## SERVICE BULLETIN

**BULLETIN # 03-03**

**SUBJECT: 42 CONVERTIBLE STEERING CLEVIS PINS**

**HULL #s: #31 THRU #170**

CLEVIS PIN

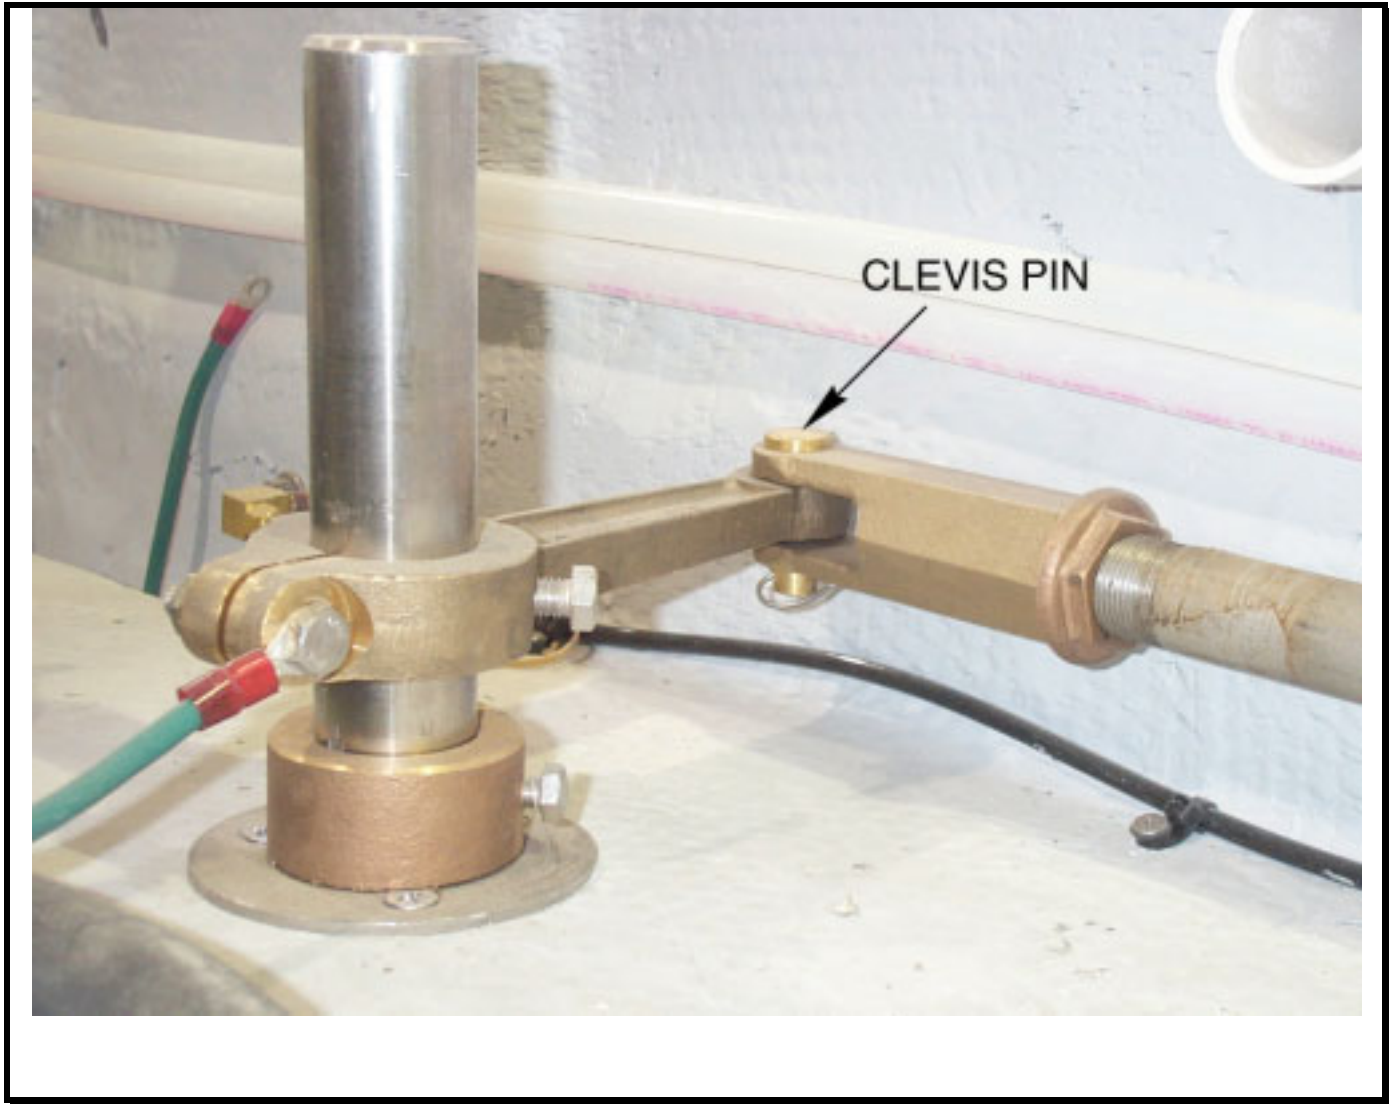
It has come to our attention that the steering clevis pins on certain 42 convertibles have shown excessive wear. Because this system has a large affect on the handling and performance of the boat we recommend the following repairs be done as soon as possible.

The original brass clevis pins need to be replaced by a new stainless steel clevis pin with a nylon bushing. All parts should be ordered thru the customer service department.

- 2 ea. Stainless clevis pins
- 2 ea. Nylon bushings
- 2 ea. 1 ¼ X 1/8" Cotter pin
